# CAMBRIDGE CITY COUNCIL – SOUTH AREA COMMITTEE 10<sup>th</sup> DECEMBER 2009

## 4.2 Grantchester Road traffic calming features

## **Consultation Responses**

GRANTCHESTER ROAD TRAFFIC CALMING GATEWAY PROPOSALS

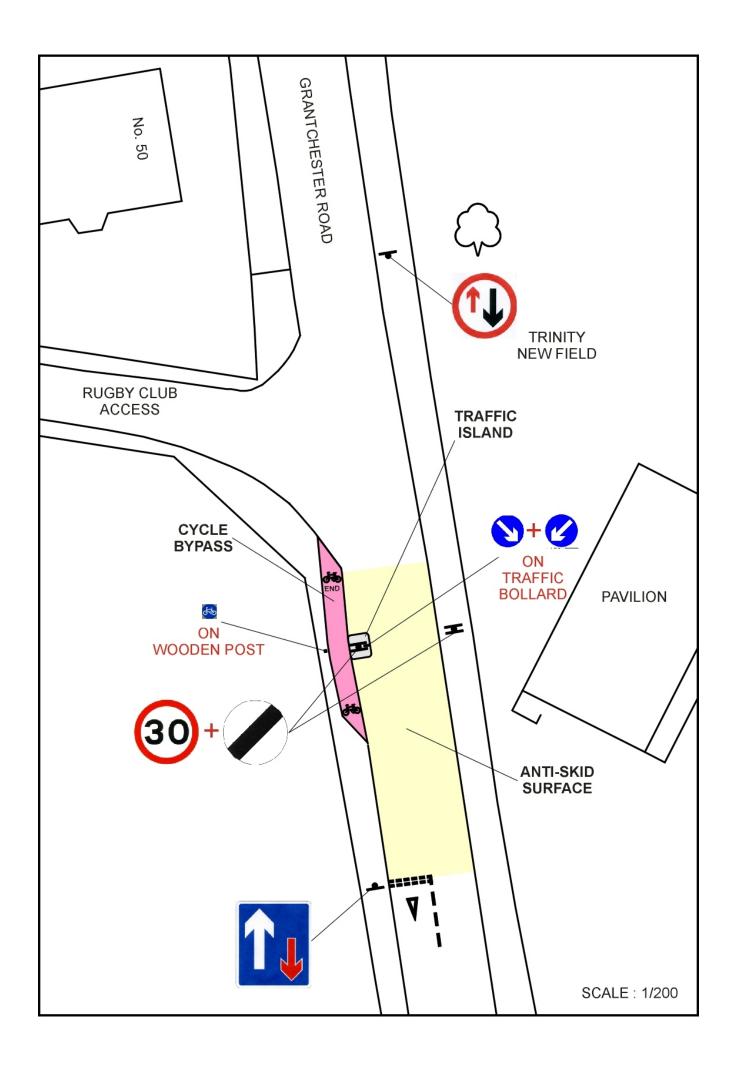
I support the proposal to introduce a 'gateway' feature as shown in the consultation leaflet: 71%

I oppose the proposal to introduce a 'gateway' feature as shown in the consultation leaflet: 17%

A second traffic island to form a chicane

The traffic island could be made more attractive

It is recommended that, if the 'gateway' is implemented, the traffic situation is monitored for a year, after which consideration be given to undertaking a second public consultation as to whether further traffic calming measures are required.
